## Lower End Cap Seal Change - 1992 40 (4 Cylinder)

### Mariner and Mercury

40 (4 Cylinder)

a - Date Code Stamp Location

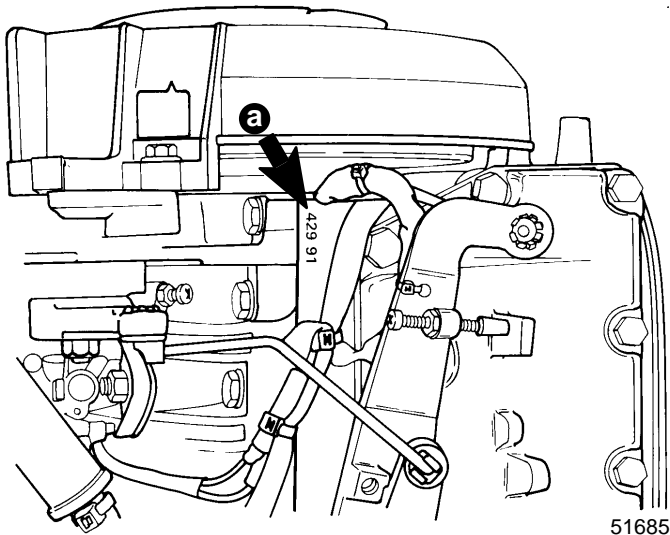
Service powerheads with this new seal arrangement, are identified by date code 429 91 and later. The date code stamp is located on the port side of the powerhead, near the cylinder block/crankcase cover split line.

- a - End Cap
- b - Seal-Bottom
- c - Seal-Top
- d - O-Ring
- e - Bearing

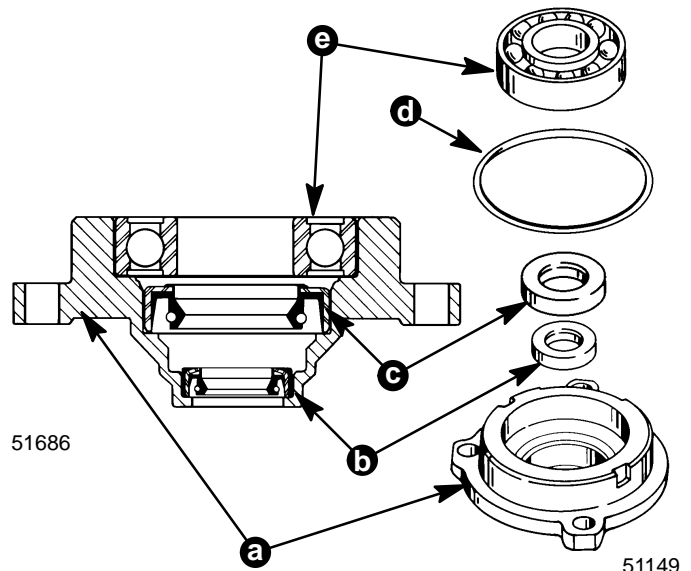
Starting with models listed, both seals in the lower end cap have the lip facing down. Previously, seals were arranged with the top (crank shaft) seal lip facing up and the bottom (drive shaft) seal lip facing down.

When servicing any 40 (4 cylinder) powerhead which has a lower end cap marked 1158-9843-C1, install both seals in the lower end cap with seal lip facing down.
